GLOBAL MINOR AMENDMENTS TO ENTIRE DEIR

The entire DEIR has been revised to make the following minor global revisions:

AMENDMENTS TO SECTION 2.0, PROJECT DESCRIPTION

Figure 3.7-1

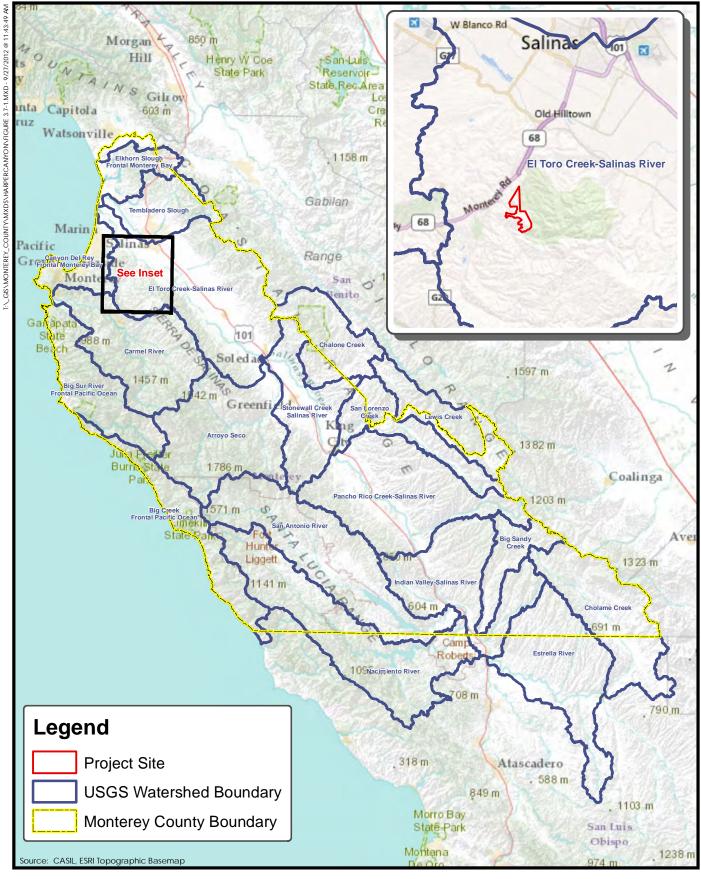
On page 3.7-3 of the DEIR a new Figure 3.7-1, U.S. Geological Survey Watersheds within Monterey County figure has been added before section 3.7.2, Regulatory Setting. This added figure subsequently renumbered Figure 3.7-1, Watersheds and Proposed Detention Basins as Figure 3.7-2. All references to Figure 3.7-1, Watersheds and Proposed Detention

Basins throughout the DEIR have subsequently been revised to reference Figure 3.7-2, Watersheds and Proposed Detention Basins.

The project site is located in the southeastern section of the Monterey Peninsula<u>El</u> Toro Creek-Salinas River subarea of the Salinas watershed as shown in **Figure 3.7-1**. The Salinas Valley drains an area of approximately 3,950 square miles to the Salinas River. The watershed basin consists of deep alluvial deposits that are several hundreds of feet thick. The groundwater basin in this area is recharged primarily through percolation from the Salinas River during the rainy season. Average annual flows to the ocean from the Salinas River are approximately 282,000 acre-feet per year (AFY) during the spring and summer months. The two reservoirs on the Nacimiento and San Antonio Rivers regulate flow to minimize outflow to the ocean and to maximize groundwater recharge through the Salinas River bed.
